# Design Revisions Item #7 - Exterior Materials

# Design Revisions Item #9 - Balcony Adjustments and Lightened Grid

# Design Revisions Item #9 - Balcony Adjustments and Lightened Grid

Zoning Hearing (October 1)

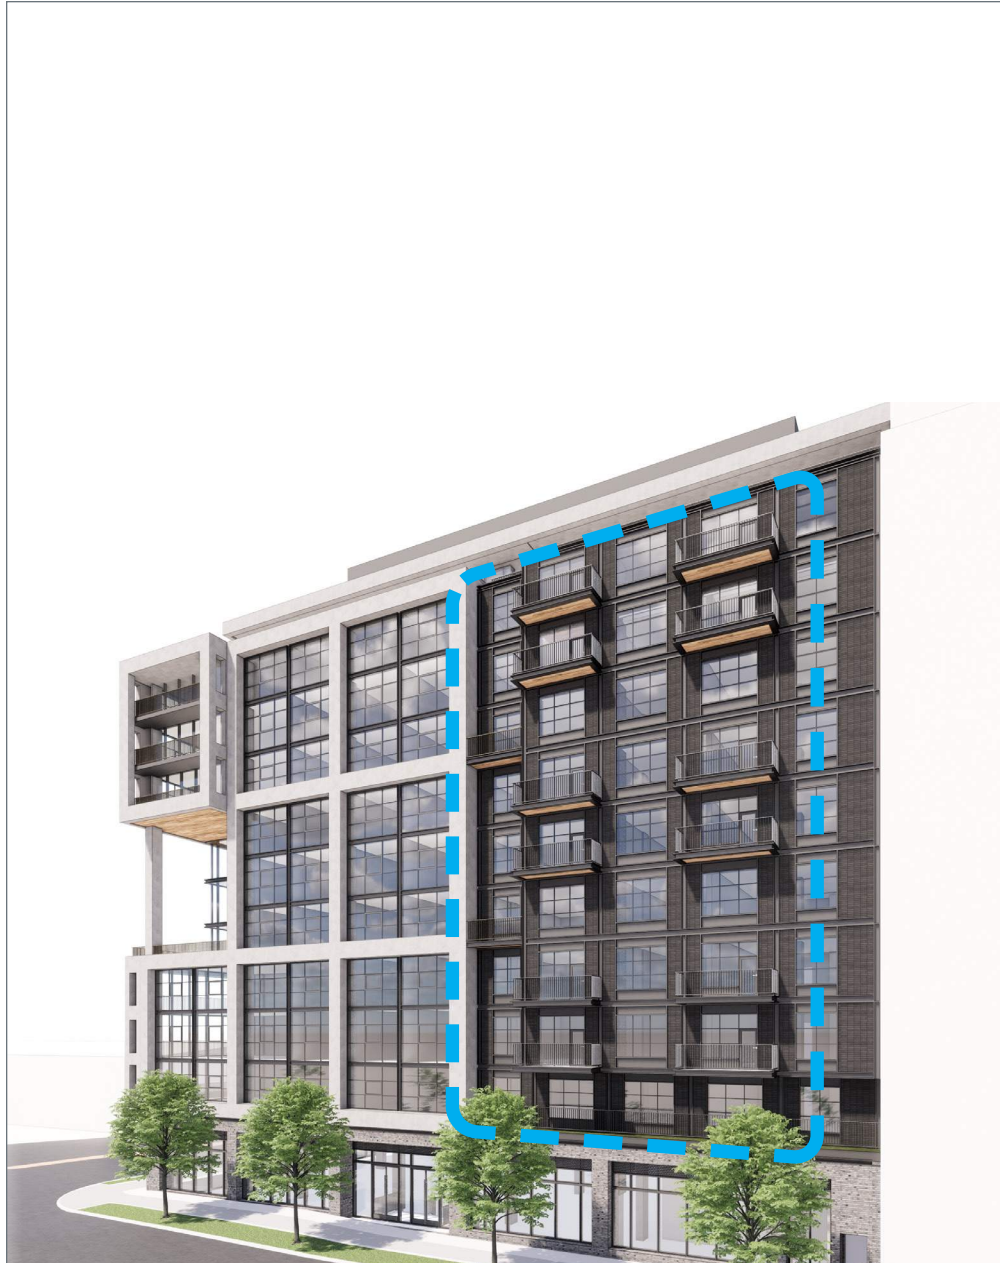
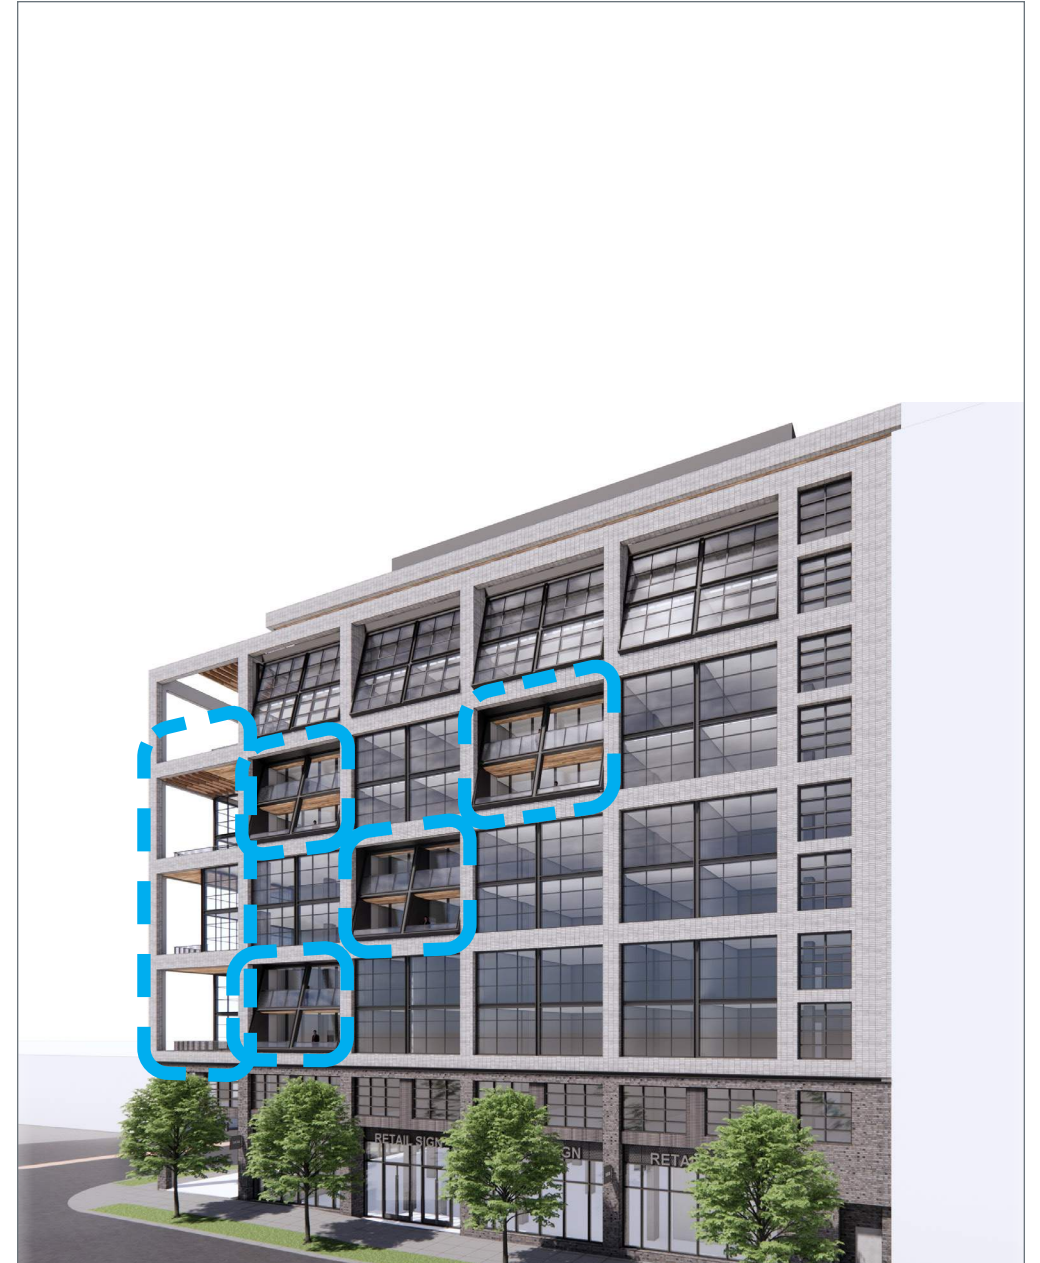
Added Balconies

Added Additional Balconies

### Revised 'Hyphen' Facade

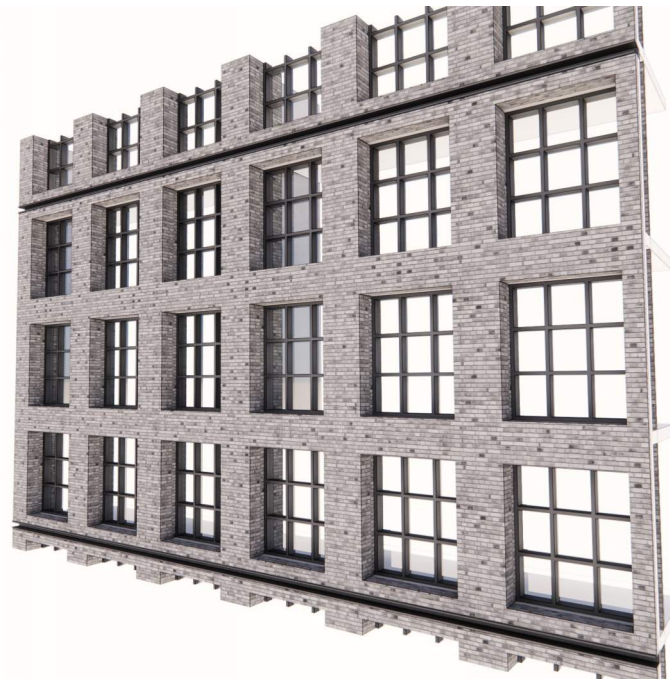
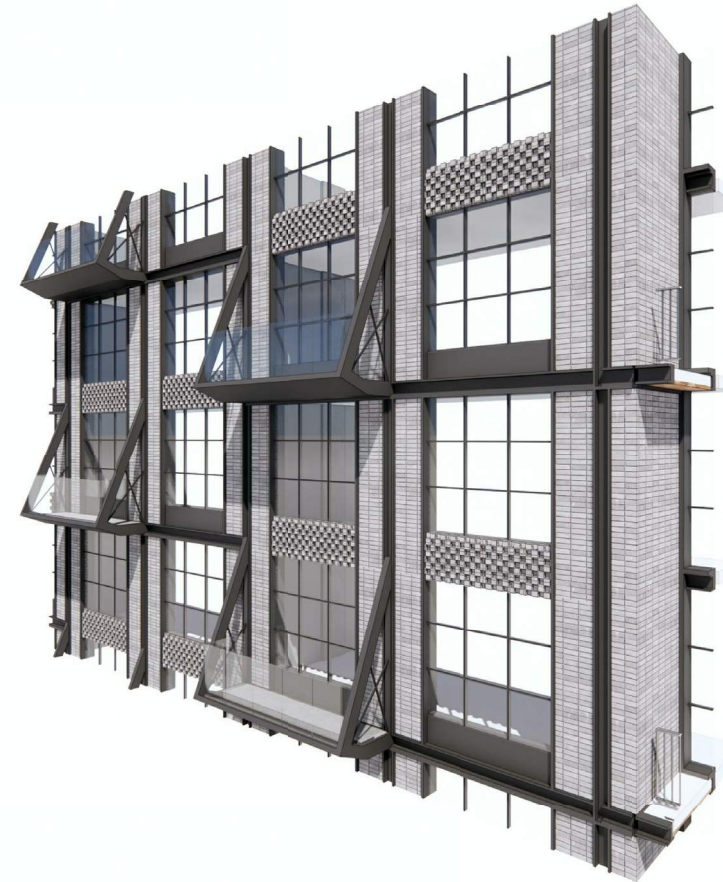
- Stacked bond brick creates a more mid-century aesthetic.
- Brick surfaces are captured by metal elements similar to mid-century references in the neighborhood.
- Increased glass and light.

- Replaced the dark charcoal brick with a lighter grey brick.
- Replaced metal spandrel with decorative brick.
- Revised balcony detail to evoke the rotated windows on the southeast building.

- Replaced the dark charcoal brick with a lighter grey brick.
- Replaced metal spandrel with decorative brick.
- Revised balcony detail to evoke the rotated windows on the southeast building.

### Revised Typical Bay

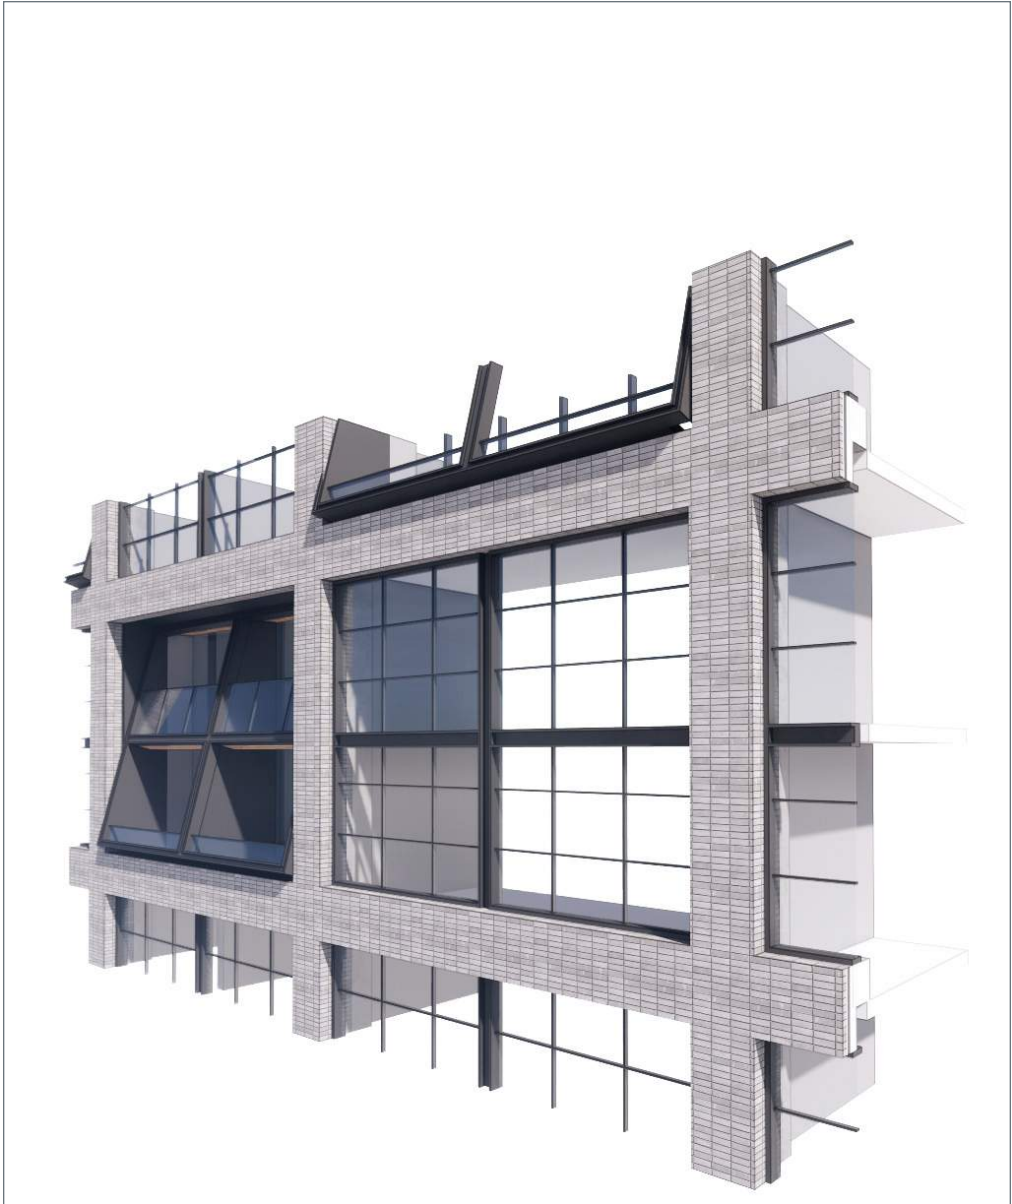
- Reduced the dimensions of the typical mullions to lighten the gridded appearance of the facade.

- Maintained lightened grid.
- Mirrored the rotation of the hopper balcony to lean inwards for both consistency across the non-balcony rotated windows, as well as to lessen the effect of the outward leaning version had on the pedestrians looking up at the building.
